**REPORT OF ALTERATIONS TO DESIGNATED RESOURCE**  
**Site Number/Address: 421 Mathews Street**  
**Laurel School National Register Historic District**  
**ISSUED: February 17, 2021**

This report is to document the summary of effects from proposed alterations to the Tomlin-Roberts Residence at 421 Mathews Street, pursuant to Fort Collins Municipal Code Chapter 14, [Article IV](#), made by the Landmark Preservation Commission at their February 17, 2021 meeting. A copy of this report may be forwarded to the Colorado Office of Archaeology and Historic Preservation.

# McCarty Remodel

**McCarty Remodel**  
421 Mathews St.,  
Fort Collins, CO

**1 Main Level Demolition Plan**  
Scale: 1/4" = 1'-0"

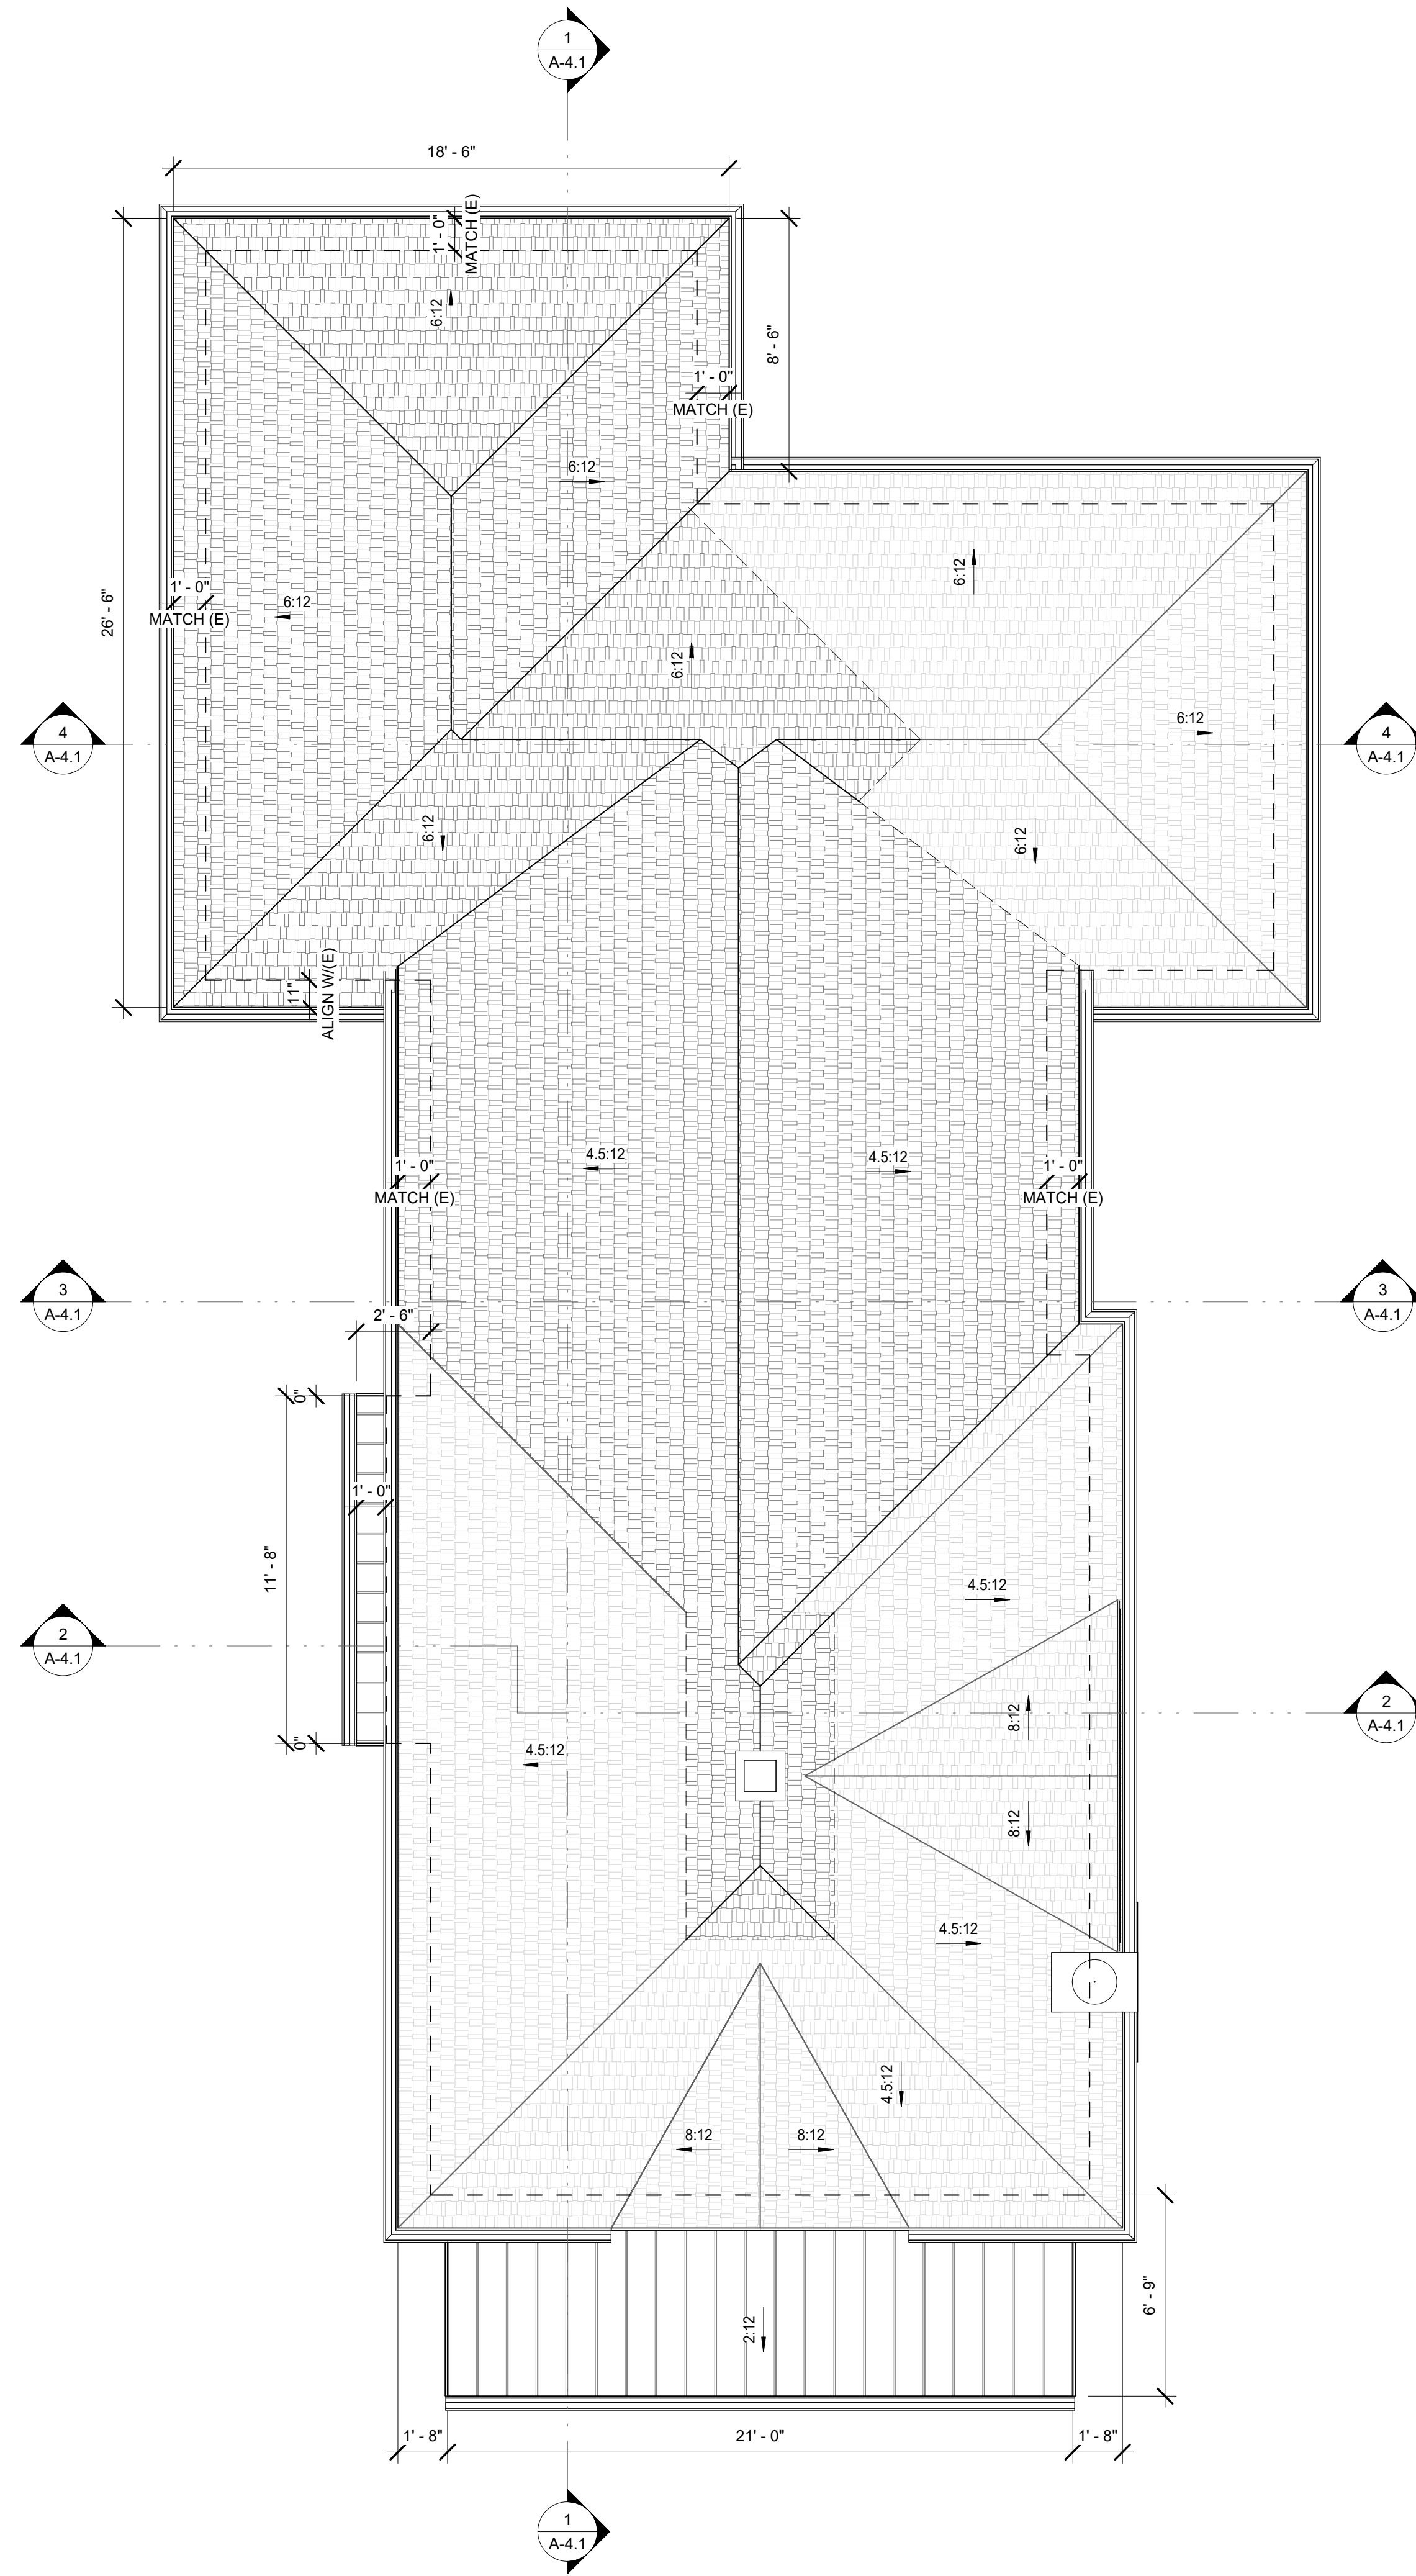
- What is the motivation to change the type of windows? Why the change from sash to casement and why the change in overall glazing pattern?

The type of windows are not changing, the demo plan shows existing casement windows and will be installed back as a casement window, not a sash.

The change to the front windows for glazing pattern to match the rest of the windows. The front windows are not original window patterns. Based on Photo 3, the 4 square is appropriate for the rest of the existing windows around the house.
